E/ECE/324
E/ECE/TRANS/505 } Add.7/Rev.3/Amend.2

Addendum 7: Regulation No. 8

Revision 3 - Amendment 2

UNIFORM PROVISIONS CONCERNING THE APPROVAL OF MOTOR VEHICLE HEADLAMPS EMITTING AN ASYMMETRICAL PASSING BEAM OR A DRIVING BEAM OR BOTH AND EQUIPPED WITH HALOGEN FILAMENT LAMPS (H_1, H_2, H_3, HB_3, HB_4, H_7 and/or H_8)

Figure 1

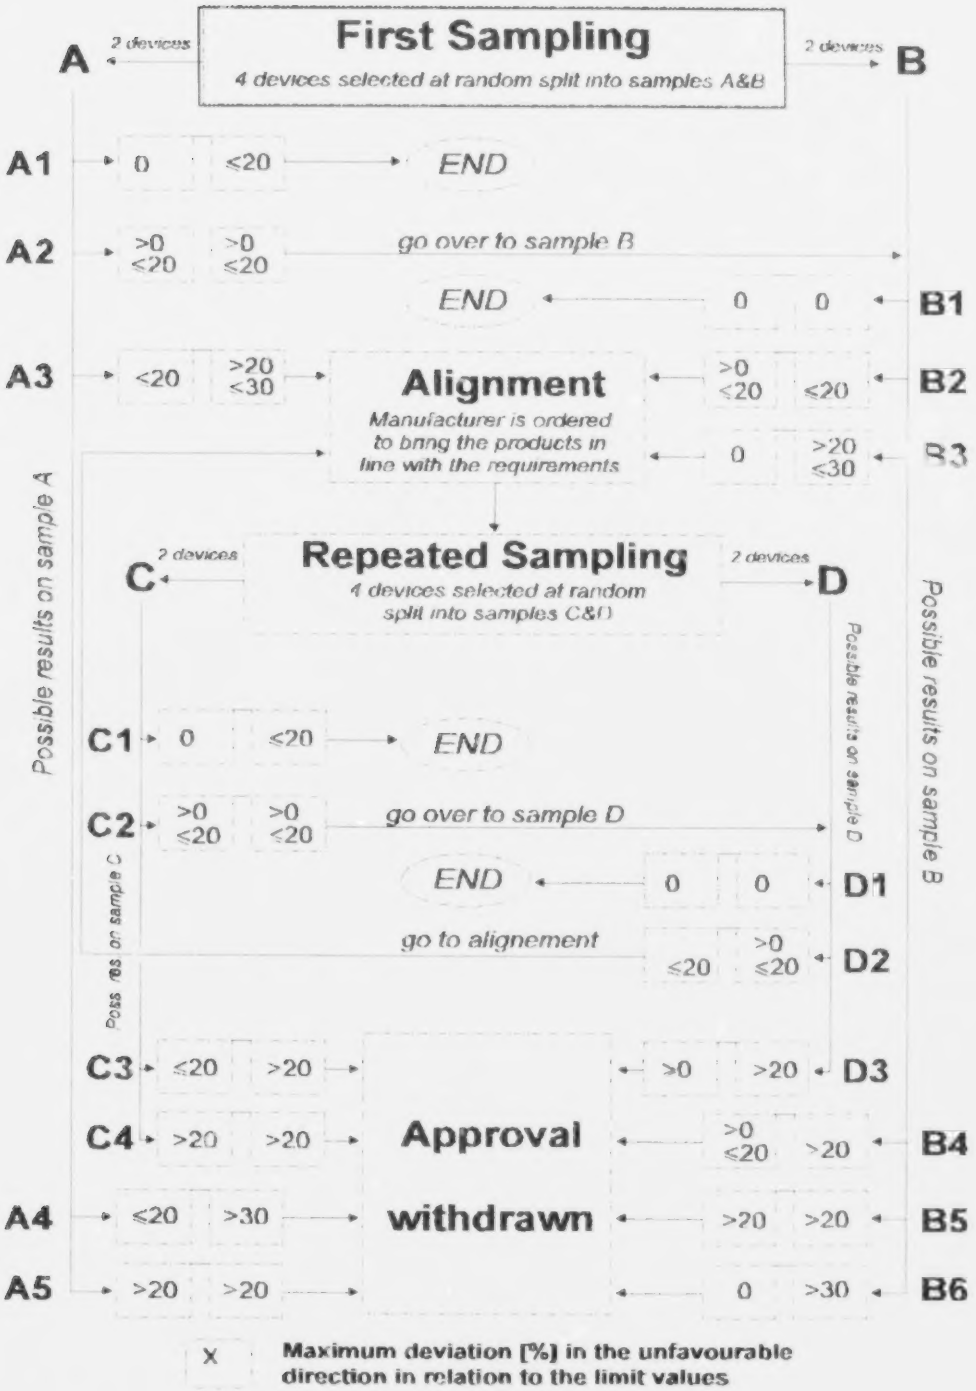
Add a new Annex 7, to read:

2.1.1. Following the sampling procedure shown in Figure 1 of this annex the conformity of mass-produced headlamps shall not be contested if the deviation of the measured values of the headlamps in the unfavourable directions are:

2.2.1. Following the sampling procedure shown in Figure 1 of this annex the conformity of mass-produced headlamps shall be contested and the manufacturer requested to make his production meet the requirements (alignment) if the deviations of the measured values of the headlamps are:

Conformity shall be contested and paragraph 13 applied if, following the sampling procedure in Figure 1 of this annex, the deviations of the measured values of the headlamps are:

3.1.1. Following the sampling procedure shown in Figure 1 of this annex the conformity of mass-produced headlamps shall not be contested if the deviations of the measured values of the headlamps are:
